| SUNDRY NOTICES AND REPORTS ON WELLS (DO NOT USE THIS FORM FOR PROPOSALS TO DRILL OR TO DEEPEN OR PLUG BACK TO A DIFFERENT RESERVOIR. USE "APPLICATION FOR PERMIT" (FORM C-101) FOR SUCH PROPOSALS.) 1. Type of Well: Oil Well <input checked="" type="checkbox"/> Gas Well <input type="checkbox"/> Other <input type="checkbox"/> | | WELL API NO. 30-015-20246 |

Linn Operating, LLC is respectfully submitting a request to plug and abandon the Collatt Estate Com #001 located in Eddy County, NM. Linn received a Letter of Violation as a result of the well being shut-in for an extended period of time and in violation of Rule 19.15.25.8. Corrective action needs to be completed by 9/10/2017.

COLLATT ESTATE COM, WELL NO. 1
J-01-T23S-r26E
Eddy County, New Mexico

PROPOSED PLUG AND ABANDONMENT PROCEDURE

PROPOSED

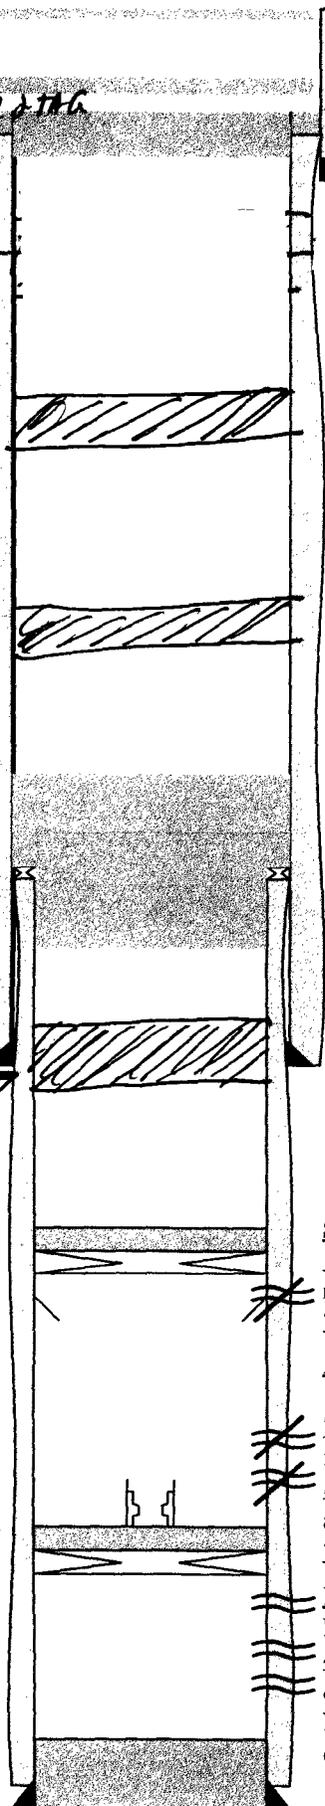
WOC & TAG

PERF & SQ - 2000'
WOC & TAG

ADD A PLUG @ 5319'
TO 5219' - COVERS B/S

ADD A PLUG @ 8764'
TO 8664' - COVERS W/C

WOC & TAG

PERF & SQ @ 9693'
WOC & TAG

WOC & TAG → Proposed: CIBP @
10,403' w/ 20' cmt
35'
